**Request for Additional Information No. 448(4898, 5084)
Question 03.08.01-51 and Question 03.08.01-52, Revision 1**

U.S. EPR Standard Design Certification

SRP Section: 03.08.01 - Concrete Containment

Question 03.08.01-51:**Follow-up to RAI 155, Question 3.8.1-22**

**Figure 03.08.01-51-1—Coarse Slice Model Mesh Density (a) Typical RCB
Section (b) Typical RCB Dome (c) Typical RCB Wall**

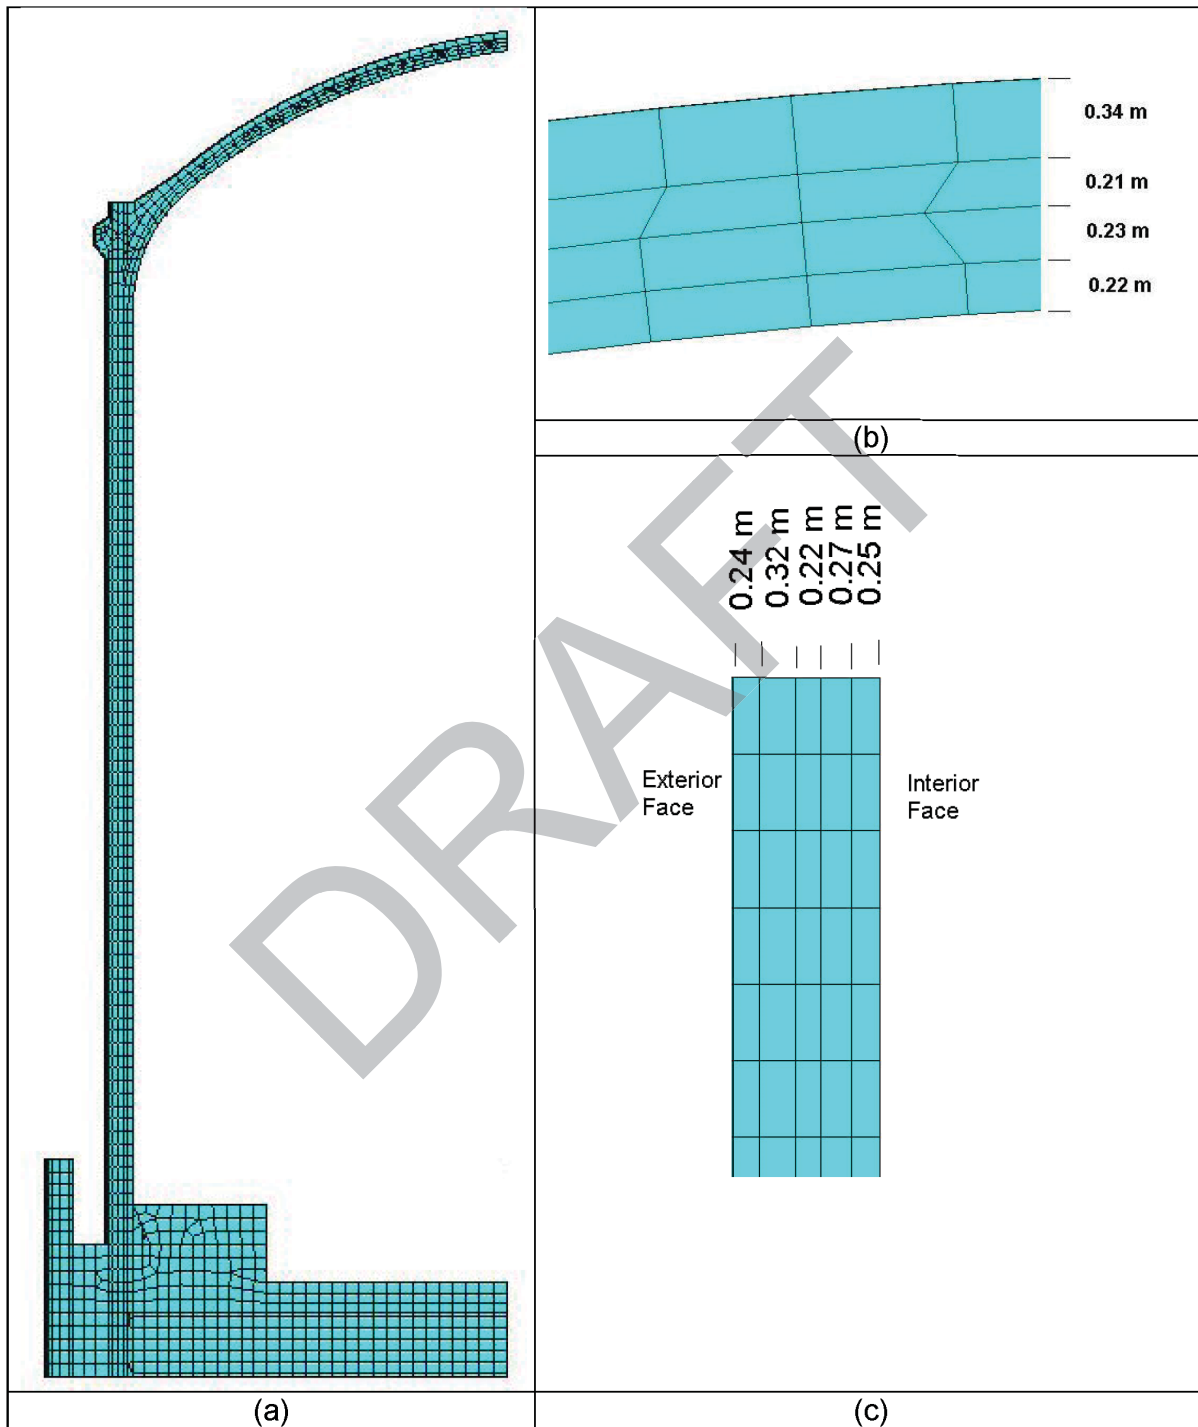
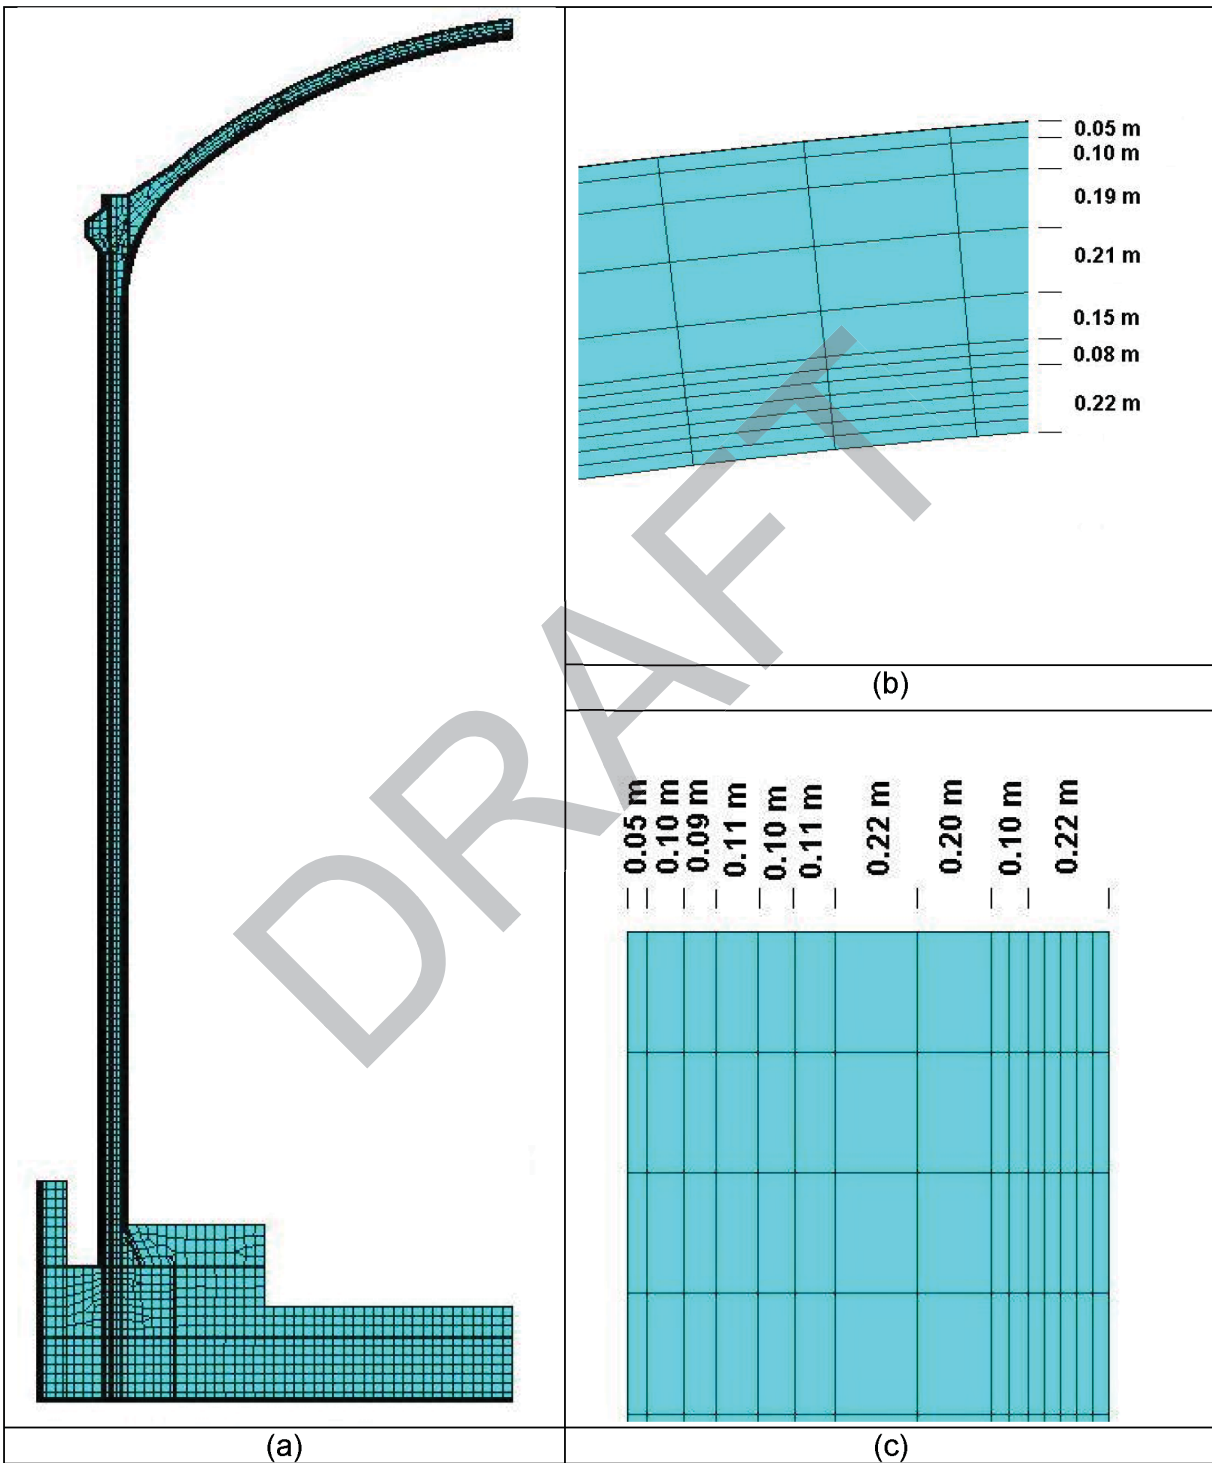
- a. The RAI response states that the mesh density in the 6-degree slice FEM model is increased to calculate the change in thermal moments due to mesh refinement. Provide a description of this mesh refinement, include a figure of each model, and identify the relative sizes of the original vs. the refined mesh.

In response to RAI 03.08.01-22, six-degree slice finite element model (FEM) models were considered with a coarse mesh density and refined mesh density. The slice model with coarse and refined mesh densities are referred to as “equivalent slice model” and “refined slice model,” respectively. The equivalent slice model has similar element thickness and mesh density as the Nuclear Island (NI) static model RCB, and contains five and four elements through thickness of the RCB wall and dome, respectively. The refined slice model has 15 and 12 elements through thickness of the RCB wall and dome, respectively. The equivalent and refined slice models are used for linear structural analysis of the model.

Figure 03.08.01-51-1 and Figure 03.08.01-51-2 show mesh densities of the RCB wall and dome for equivalent and refined slice models.

Figure 03.08.01-52-1—Comparison of Temperature Gradients across the Thickness at Elevation 65.86 ft for (a) Steady State Condition, (b) 1200 Seconds, (c) 1.39 Hours, (d) 24 Hours, (e) 110 Hours, and (f) 1 Year

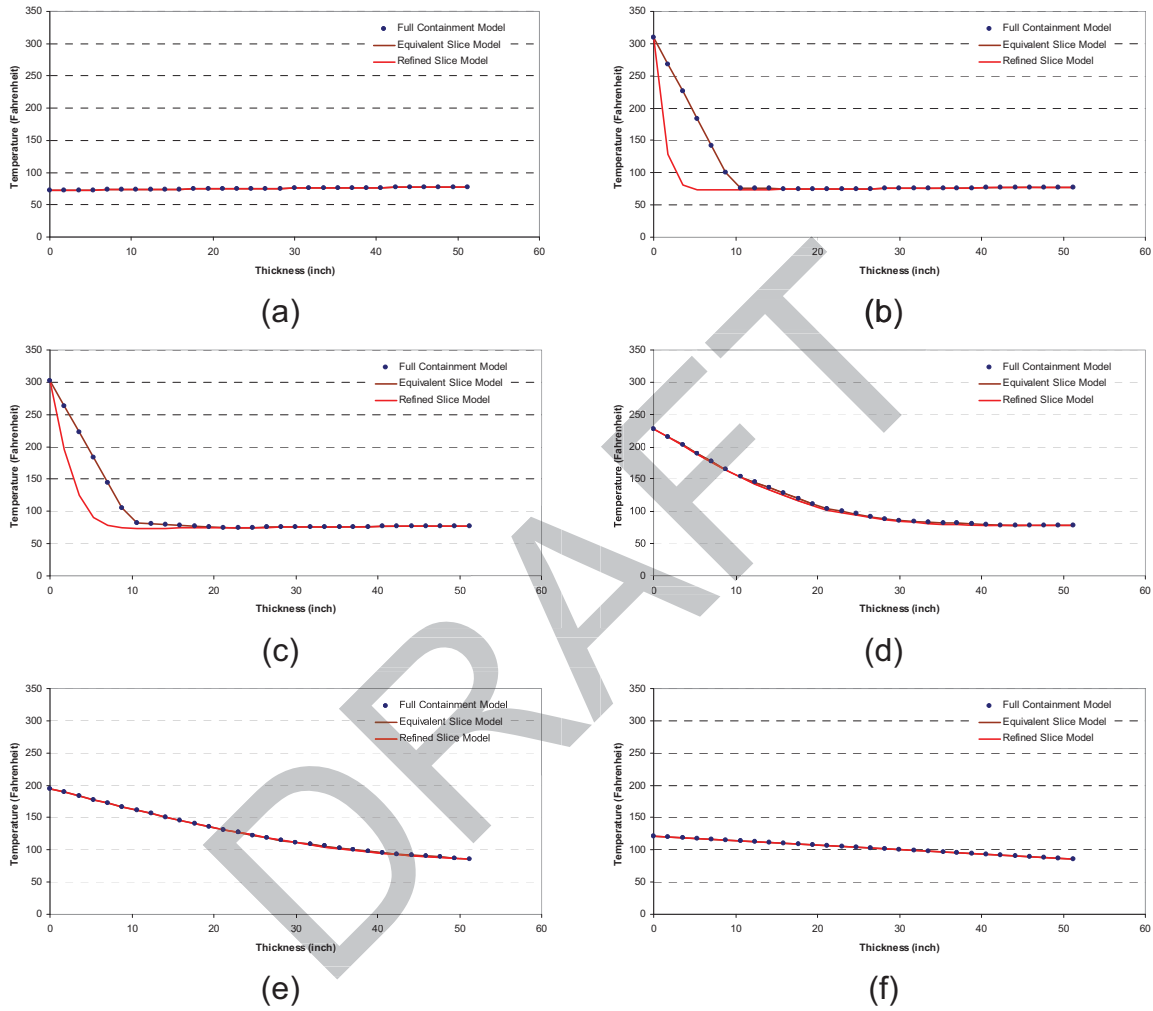
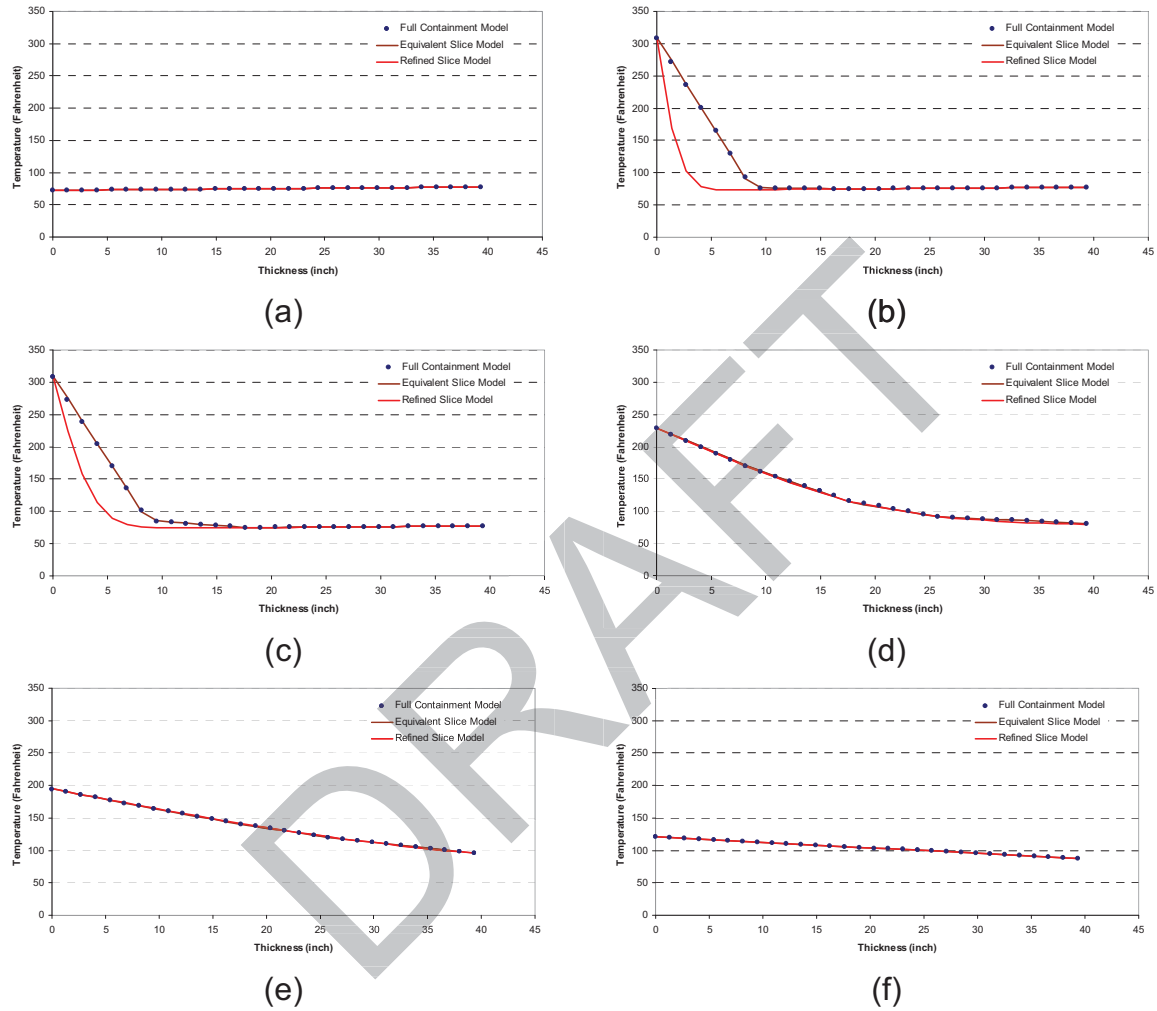
- a. Item 1 of the RAI response indicates that a six degree slice of the containment is studied for mesh refinement in consideration with thermal moment calculations, presumably as described in the response to RAI 3.8.1-22. Based on this study, AREVA indicates that the existing 4/5 element mesh through the thickness of the RCB overestimates the thermal gradient across the thickness, at the beginning of the accident period, and provides an accurate estimate of the thermal gradient at the later period of the accident, compared to the thermal gradient for a refined mesh. To complete the response to Item 1 of the RAI, provide some representative (max., min.) comparison results determined in this study, for selected elements/regions of the RCB, such that the magnitude of the stated conservatism can be quantified. Since the computed thermal moments are subsequently reduced by "thermal moment reduction factors," as explained in the response to RAI 3.8.1-22, confirm that this conservatism is actually eliminated from the forces/moments used in the RCB design. Information regarding this issue should be provided in conjunction with the response to the follow-up to RAI 3.8.1-22, Items 1 and 2.

Variation in temperatures through the thickness of the containment wall (at 65.86 feet) and dome (75 degrees from horizontal) at different time points for the equivalent slice model and refined slice models are shown in Figures 03.08.01-52-1 and 03.08.01-52-2.

Thermal moments at the containment wall (at 65.86 feet) and dome (75 degrees from horizontal) sections for the equivalent slice model and refined slice model are shown in Table 03.08.01-52-1 and Table 03.08.01-52-2, respectively. Thermal moments from the refined model are significantly reduced at the beginning of the accident time period because of better
